Rezoning Application: RZ-PD 25-0579

Hillsborough
County Florida

Development Services Department

APPLICATION NUMBER: PD 25-0579

8.0 PROPOSED SITE PLAN (FULL)

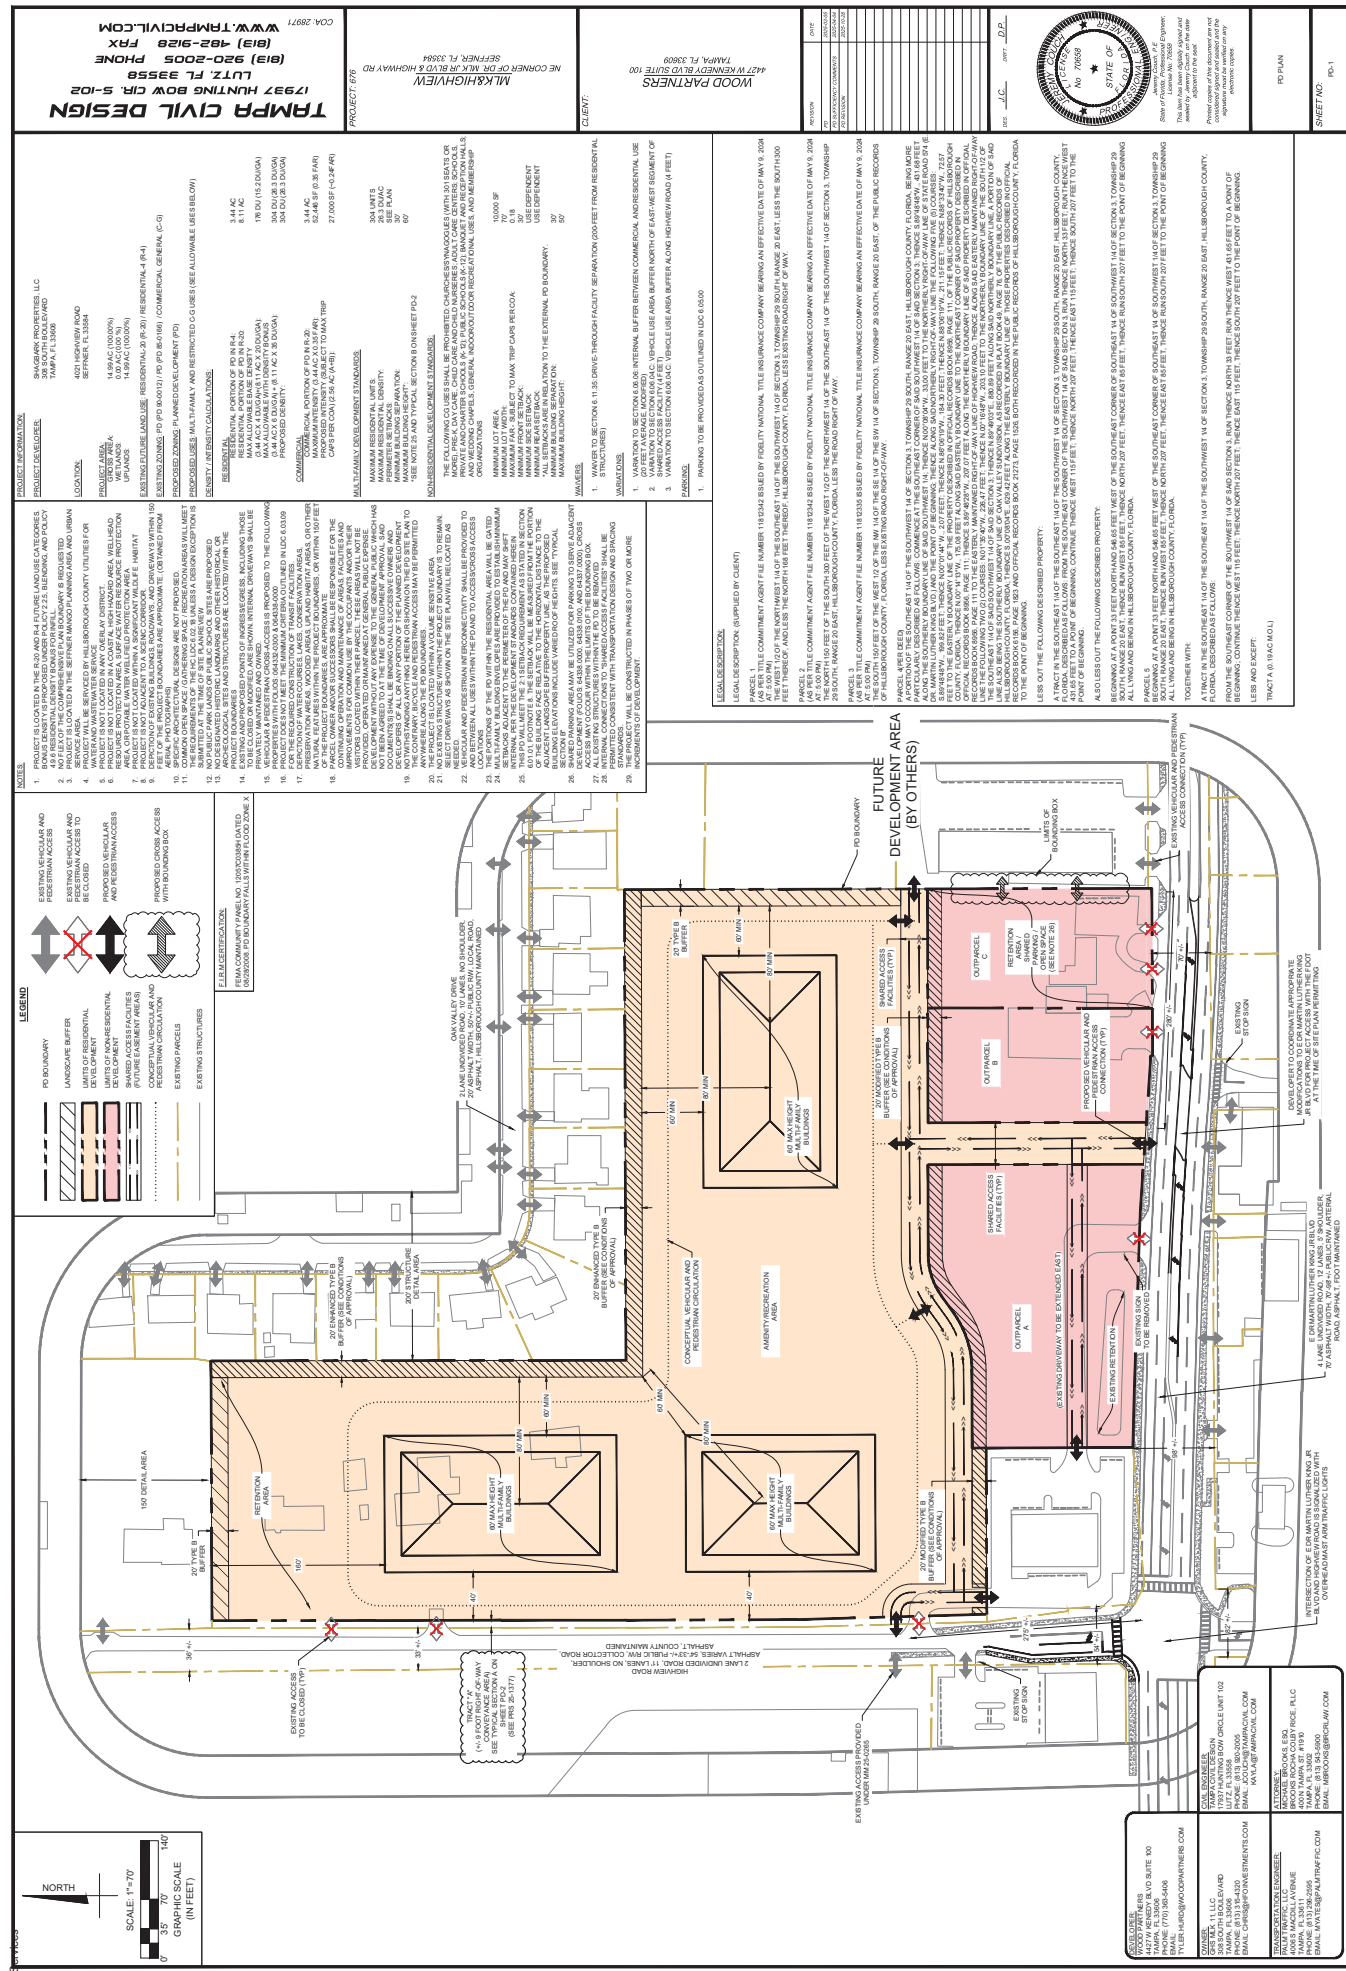
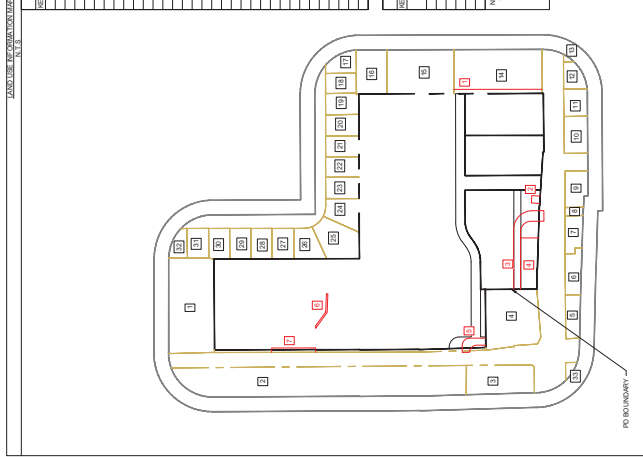
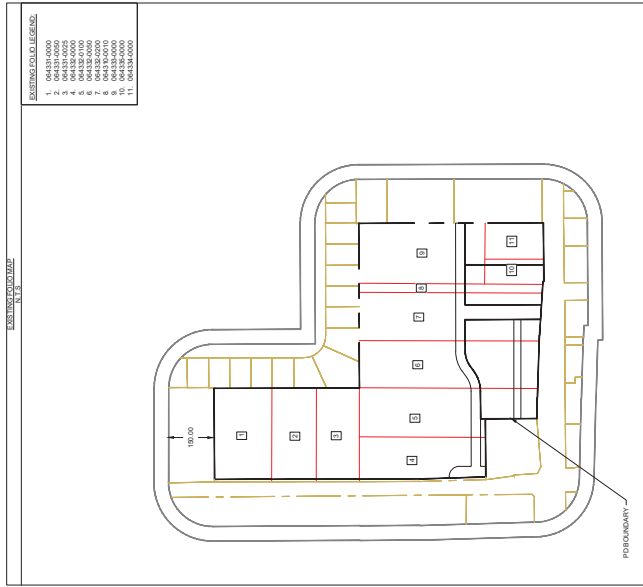
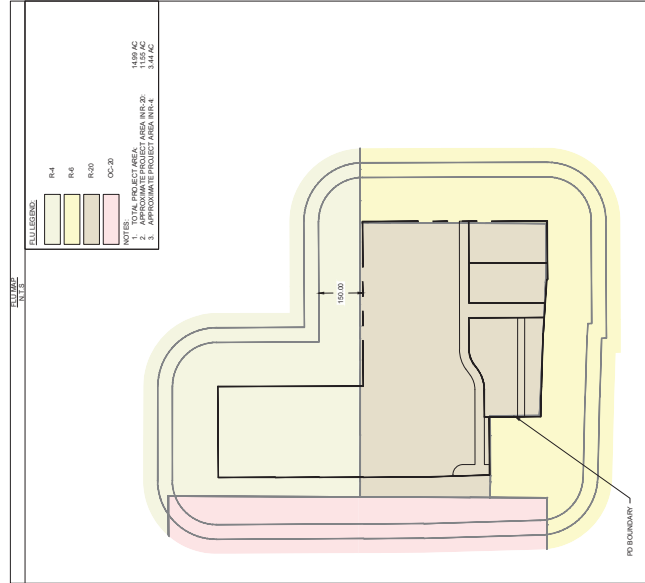
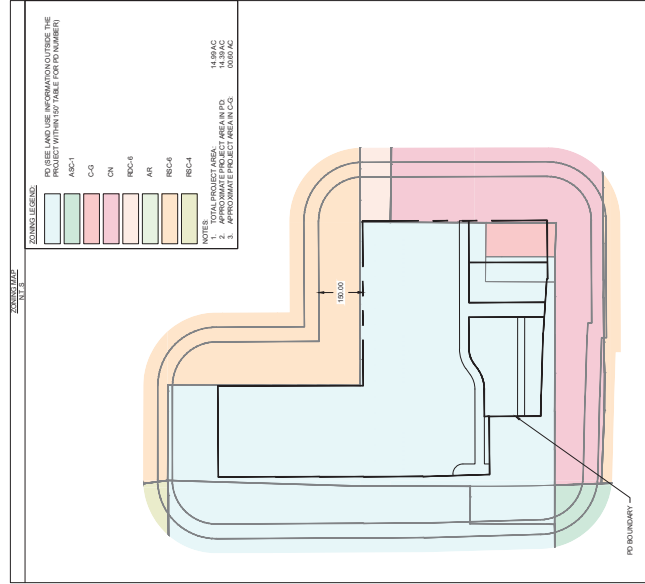
Prior to PD site plan certification, the applicant shall revise the PD site plan as follows:

- Prior to site plan certification, the PD Site Plan shall be revised to label the proposed access to the east as “Vehicular and Pedestrian Cross-Access.”

HIGHVIEW ROAD
TYPICAL SECTIONS

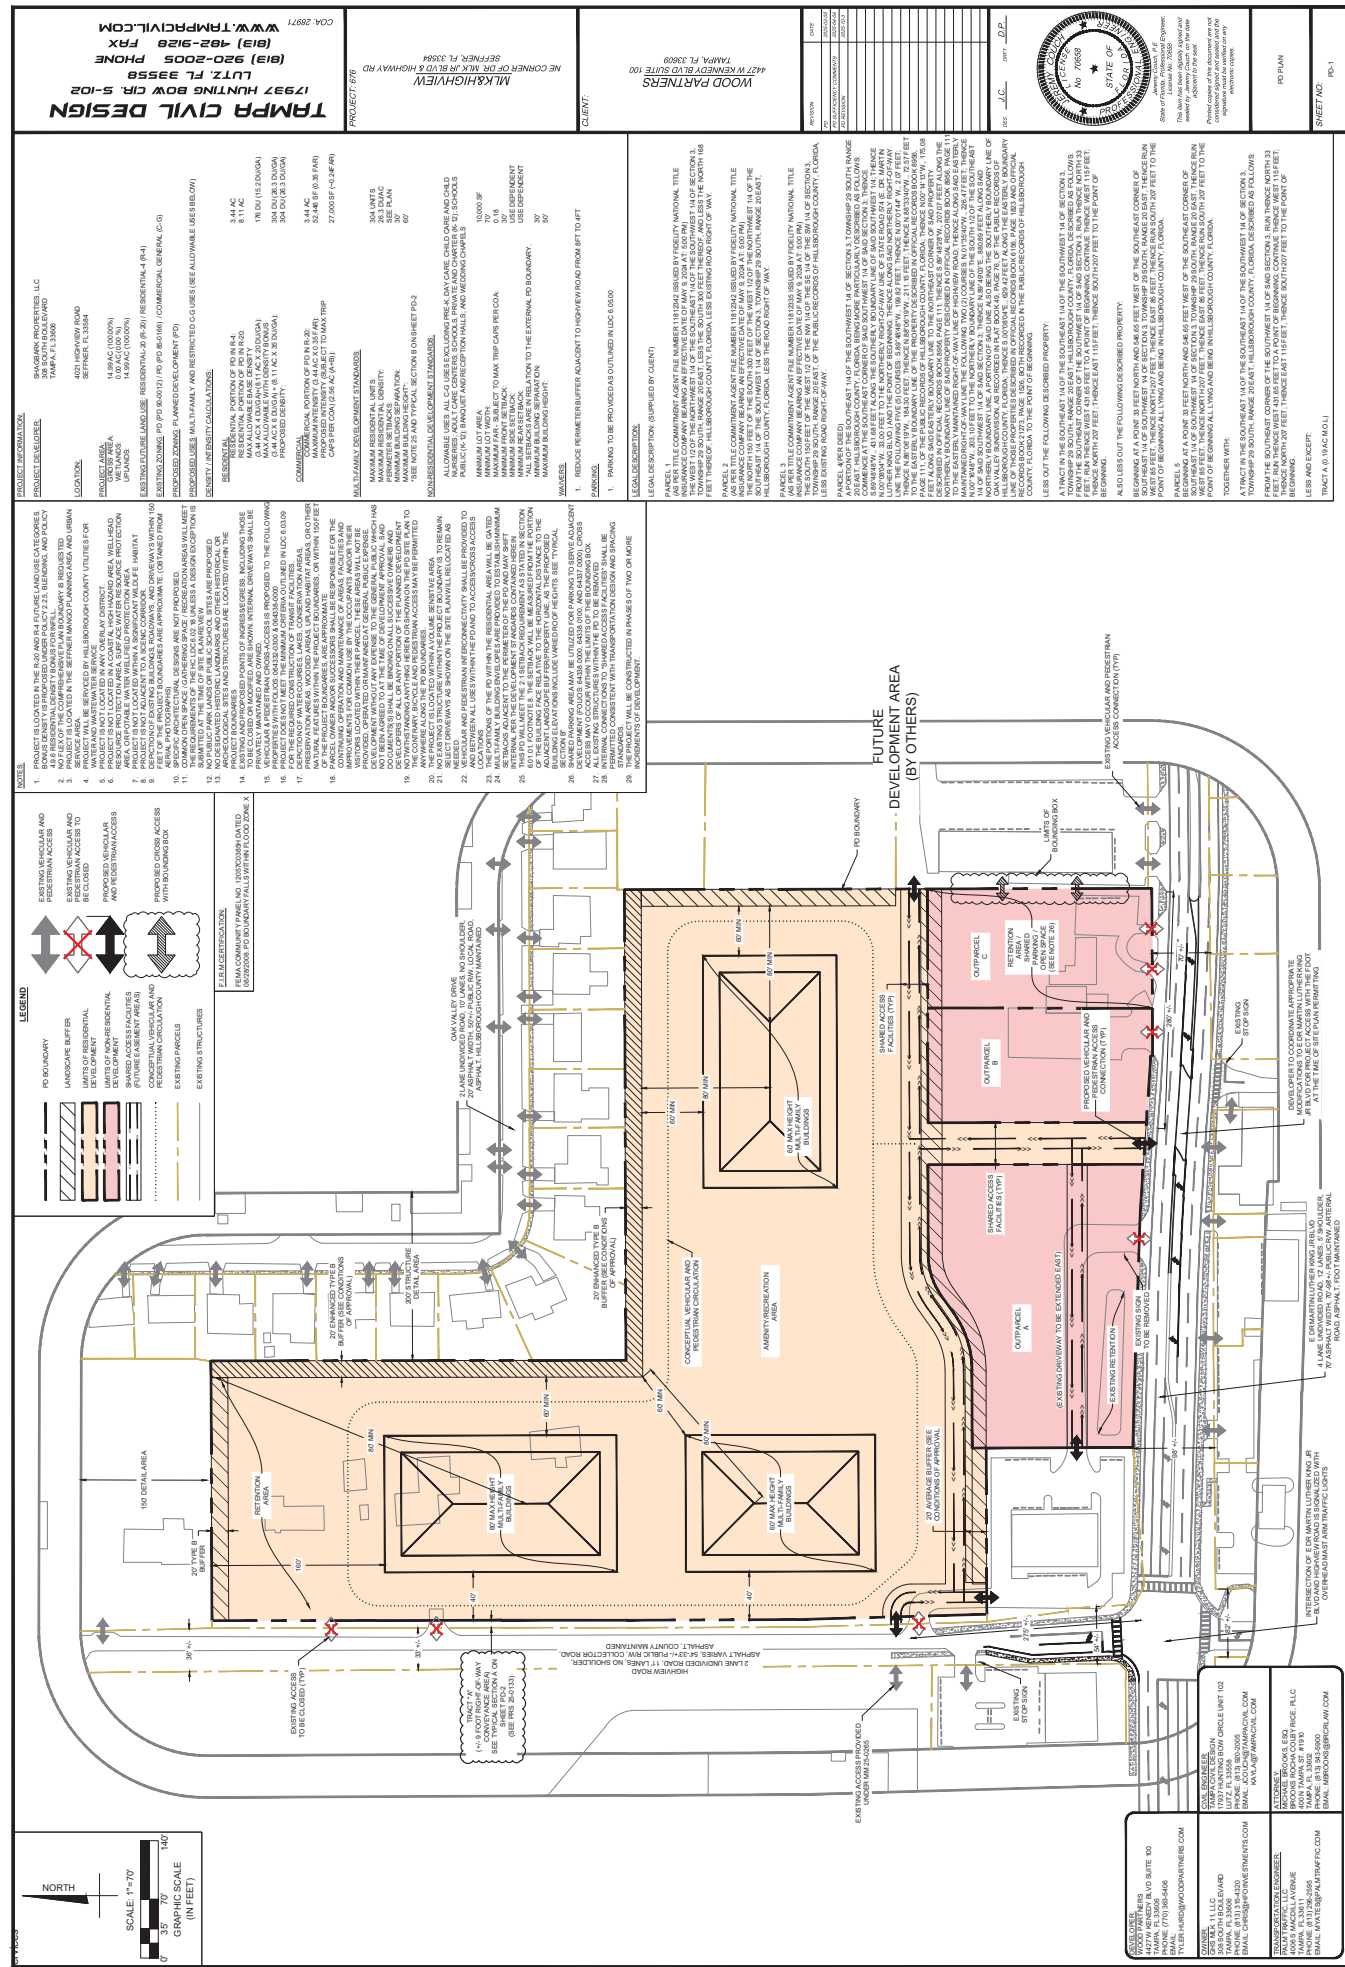
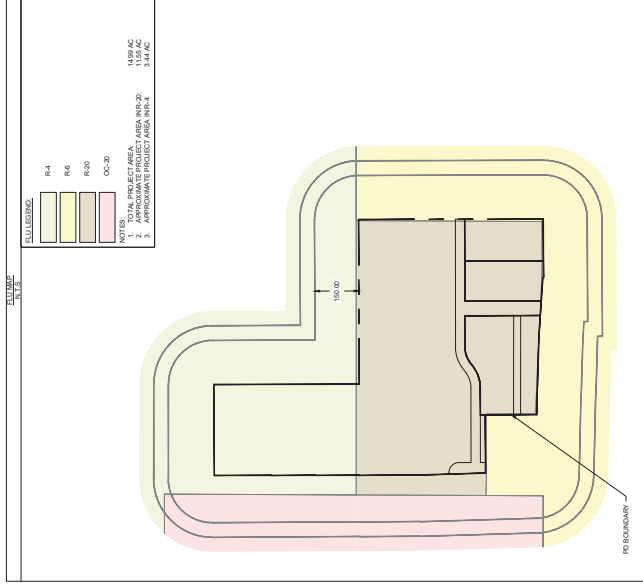
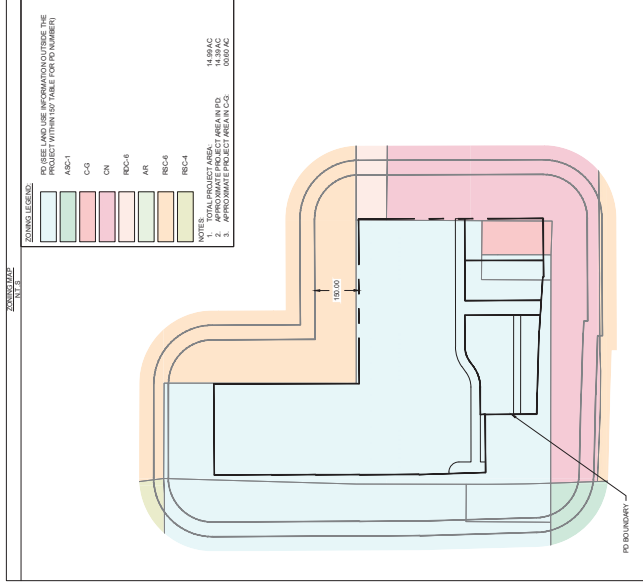
1. The request is to provide 10-foot travel lanes instead of the 11-foot travel lanes with 7-foot buffered bicycle lanes. According to the Florida Green Book, on a suburban roadway where the speed limit is between 25 and 35 mph, 10-foot travel lanes may be used. The post speed limit on Highview Road is 25 mph.

2. Provide a 10-foot wide, 95-foot-long northbound right turn lane at the project driveway. The length includes a 50-foot taper. According to the Florida Green Book, on a suburban roadway where the speed limit is between 25 and 35 mph, 10-foot auxiliary lanes may be used. The post speed limit on Highview Road is 25 mph.

2. A 9-foot area (Tract A) will be dedicated to accommodate the F type curb, sidewalk and a 2-foot strip behind the sidewalk.
3. A 6-foot sidewalk will be provided along the east side of Highview Road at the back of curb. On the west side of Highview Road, a sidewalk will be constructed as part of MM 25-0265.

- The developer shall be permitted to provide 10-foot-wide travel lanes rather than the 11-foot-wide travel lanes with 7-foot-wide buffered bicycle lanes required per TS-4; and,

- The developer shall be permitted to provide 10-foot-wide travel lanes rather than the 11-foot-wide travel lanes with 7-foot-wide buffered bicycle lanes required per TS-4; and,
- The developer shall be permitted to provide a 10-foot-wide, 95-foot-long northbound right turn lane at the project's Highview Rd access; and,
- The developer shall be permitted to construct a 6-foot-wide sidewalk along the east side of Highview Rd at the back of curb except for areas where, due to pinch points, the sidewalk will be permitted to be reduced to 5 feet. The existing 5-foot-wide sidewalk on the east side of Highview Rd will remain; and,

- The developer shall be permitted to provide 10-foot-wide travel lanes rather than the 11-foot-wide travel lanes with 7-foot-wide buffered bicycle lanes required per TS-4; and,
- The developer shall dedicate a 9-foot-wide area (Tract A) along Highview Rd to accommodate the F type curve, sidewalk, and a 2-foot-wide strip behind the sidewalk; and,
- The developer shall be permitted to construct a 6-foot-wide sidewalk along the east side of Highview Rd at the back of curb. A sidewalk along the west side of Highview Rd will be constructed as part of MM 25-0265.
